CITY OF SANDUSKY BOARD OF ZONING APPEALS MEETING

**April 6, 2017
4:30 p.m.
1ST FLOOR CONFERENCE ROOM, CITY BUILDING
AGENDA**

CITY OF SANDUSKY, OHIO
DEPARTMENT OF DEVELOPMENT
DIVISION OF PLANNING

BOARD OF ZONING APPEALS REPORT

ARCHITECTURAL SITE PLAN

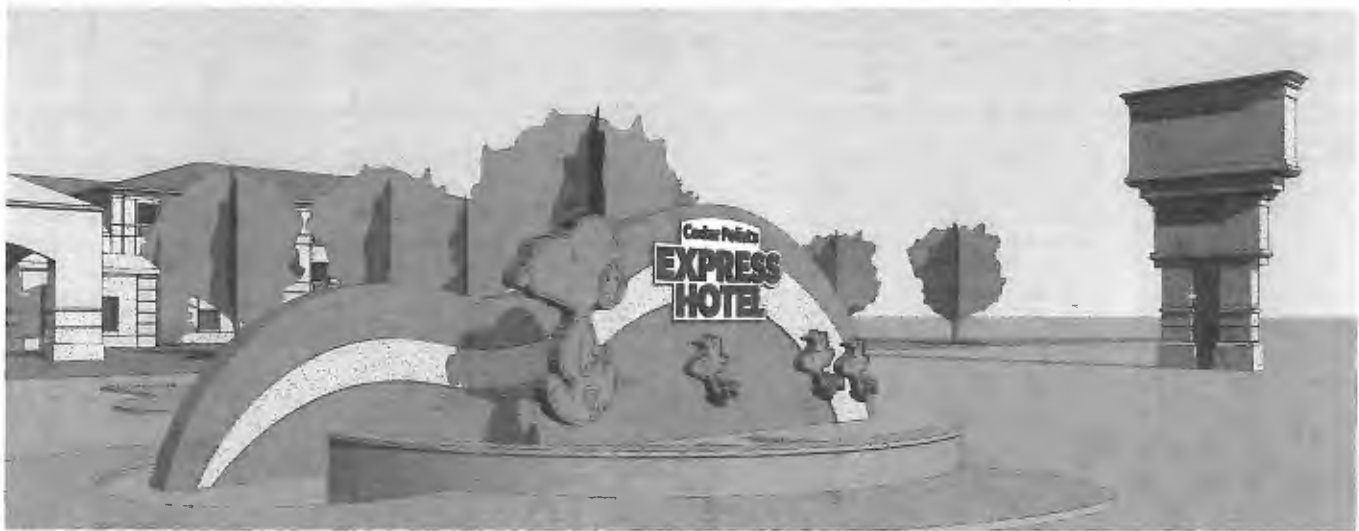
The applicant has proposed to erect a new photo-op sign structure on the front of the parcel closest to Cedar Point Drive. The sign will include Cedar Point and Hotel Breakers Express branding as well as freestanding Snoopy fiberglass characters for which tourists can take photos with. Section 1143.08(c) 2 (C) states that lots containing more than 500 feet of frontage are permitted to have two freestanding signs, with the condition that they shall be 250 feet apart. The applicant has stated that placing the signs 250 feet apart would be very difficult as the sign would not be in a viable location to either be safely erected or to take advantage of the purpose of the sign location. The applicant has proposed the two freestanding signs to be 75' apart, one of the freestanding signs is existing.

The variance sought in this case is a substantial variance, however due to the existing layout of the lot it would be difficult to place a photo- op sign in any other location on the lot.

The essential character of the neighborhood would not be altered. The property stretches more than 500 feet of frontage, the proposed sign is to be placed in the middle of the lot, and as such it would not create a line of sight issue. It is the opinion of planning staff that the properties to the east and west would not be affected. The surrounding properties include the Fire Department and a vacant parcel of land owned by Cedar Point, across the street is the Sandusky Bay.

The applicant has stated that the variance requested does arise from a unique condition, if the applicant places the sign 250' apart from the **existing** freestanding sign the proposed sign may create a line of sight issue and it could not likely be utilized for a photo opportunity as the background would be of a vacant building.

Strict enforcement of the Code would require the applicant to place the sign near the adjacent vacant lot, which as stated could create a line of site issue for cars entering or existing the parking lot.

In conclusion, planning staff recommends approval of the 150' variance to allow the two freestanding signs at 1201 Cedar Point Drive to be 75' apart.
